Project	IEEE 802.16 Broadband Wireless Access Working Group <http://ieee802.org/16>	
Title	OFDMA PHY Configuration and ASN.1 code	
Date	2006-03-07	
Submitted		
Source(s)	Joey Chou Intel Corporation 5000 W. Chandler Blvd. Chandler, AZ 85226	[mailto: joey.chou@intel.com]

Abstract	This contribution proposed the text and ASN.1 code for OFDMA PHY.
Purpose	Adoption
Notice	This document has been prepared to assist IEEE 802.16. It is offered as a basis for discussion and is not binding on the contributing individual(s) or organization(s). The material in this document is subject to change in form and content after further study. The contributor(s) reserve(s) the right to add, amend or withdraw material contained herein.
Release	The contributor grants a free, irrevocable license to the IEEE to incorporate material contained in this contribution, and any modifications thereof, in the creation of an IEEE Standards publication; to copyright in the IEEE's name any IEEE Standards publication even though it may include portions of this contribution; and at the IEEE's sole discretion to permit others to reproduce in whole or in part the resulting IEEE Standards publication. The contributor also a

23 **Figure 7—wmanIfBsPhy structure**

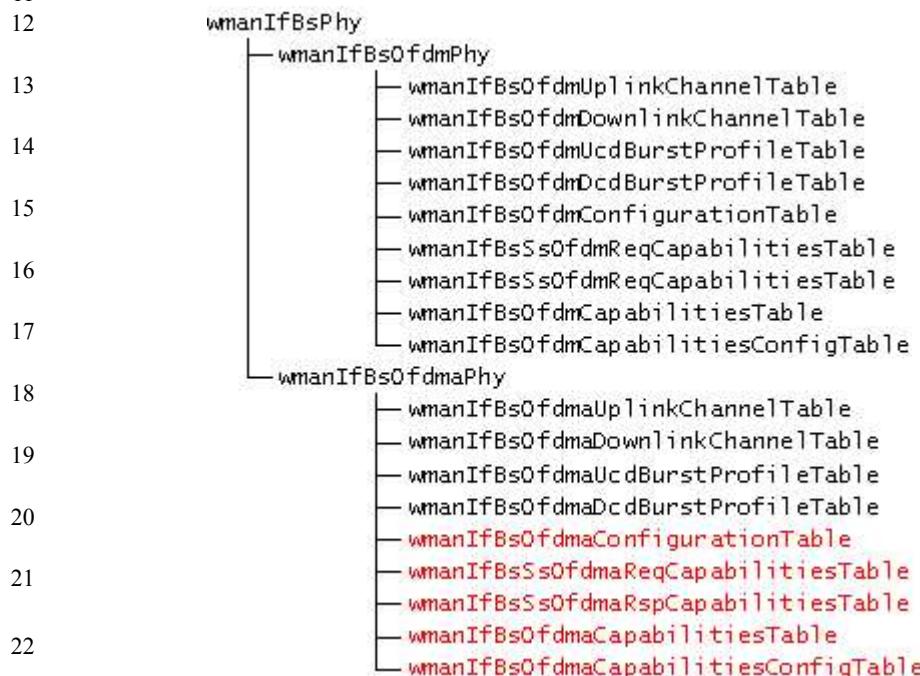
5 This section proposes new table for OFDMA PHY.

7 *[Insert a new subclause 16:]*

10 16.1.1.5 wmanIfBsPhy
